STRUCTURAL EVALUATION OF THE
SWEITZER GYMNASIUM
Cody, Wyoming

Prepared for MGT

By: J-U-B Engineers Inc.

FIGURE - A
 Frame Elevation

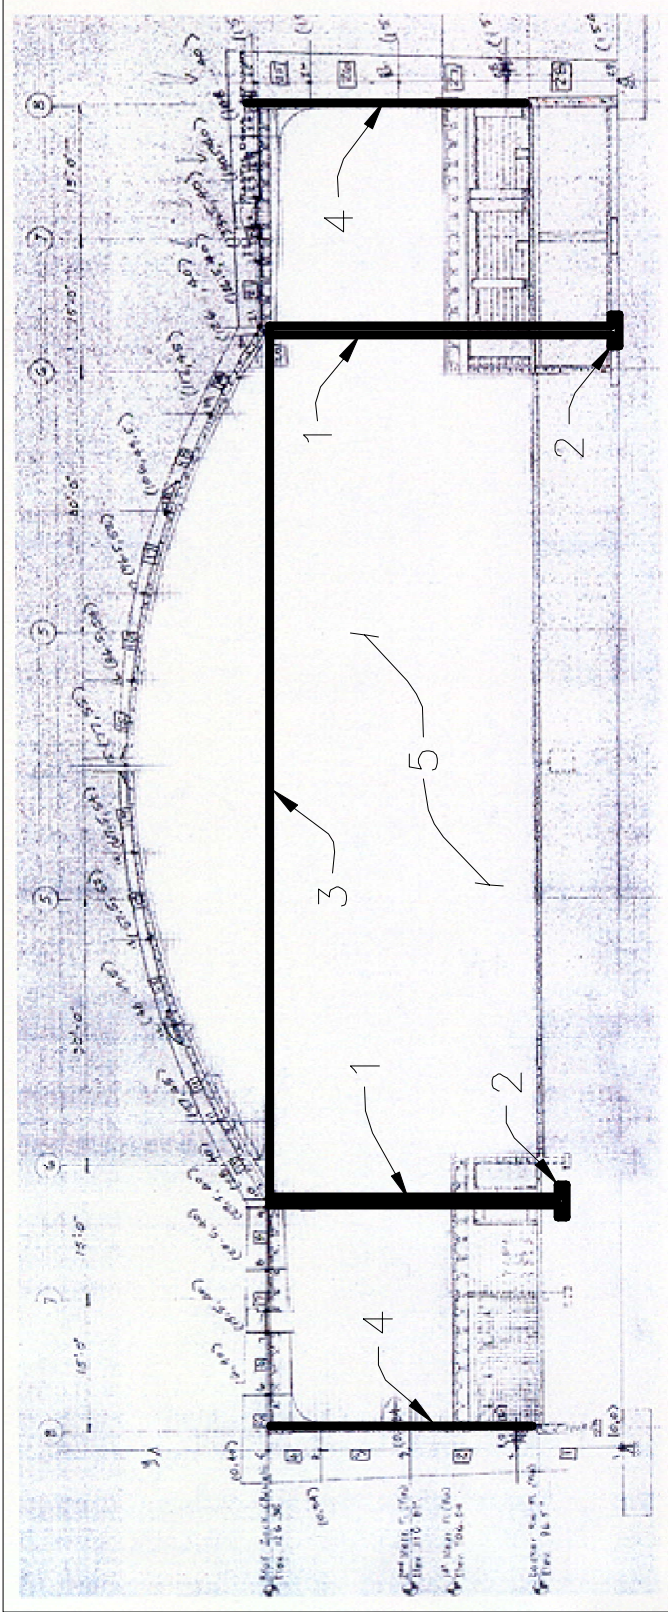
1. Provide new columns and footings under each arch at the point where the arch bears onto the supporting concrete cantilever pier.
2. New footings would be placed under each new column at the required bearing level underneath existing floors.
3. New steel tension ties would be constructed under each arch connecting each bearing location at the existing concrete cantilever pier.
4. Existing exterior masonry side-walls between each concrete pier would be removed and replaced with new reinforced masonry construction.

5. Existing exterior masonry end-walls at either end of the building would be removed and replaced with new reinforced masonry construction.

Option A is economical, in that it takes advantage of the existing adequate components and utilizes them, but some disadvantages include some architectural aspects may be lost from installation of columns in viewing areas, hallways, and other rooms and extensive amount of work would be needed to place footings in the structure beneath the columns. This option needs to be further evaluated by an architect to determine if it is viable given the limitations it will impart upon the use of the building.

- 1. NEW COLUMNS AT EACH CONCRETE ARCH
- 2. NEW FOOTINGS
- 3. NEW TENSION TIE AT EACH ARCH
- 4. NEW CMU WALLS BETWEEN ARCHES
- 5. NEW CMU WALL ENDS
